GFV-20-02a
 Presented to GFV in view of submitting
Informal document GRPE-64-xx2
 (64nd GRPE, 4 – 8 June 2012,
 agenda items 4(c) and 9)

Consolidated proposal for an amendment to Regulation No. 49 in view of type-approving Heavy-Duty dual-fuel vehicles

Submitted to GFV by the informal GFV-HDDF Task Force

Figure 1

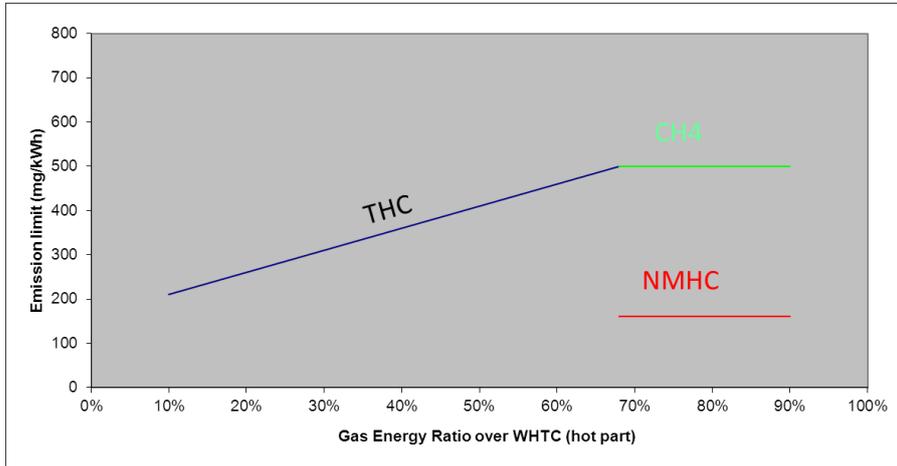
In my view as THC_{GER} is calculated based on NMHC and CH4 limits, THC emissions should be calculated as the sum of NMHC + CH4.

Remark. Is the above graph fully correct? The gas energy ratio for type 2A and 2B engines may be higher than 90% (see definitions “or that operates over the hot part of the WHTC test-cycle with an average gas ratio that is not lower than 90 per cent ($GER_{WHTC} \geq 90\%$), but that idles using exclusively diesel fuel”). The NMHC and CH4 lines should be extended to 100%?
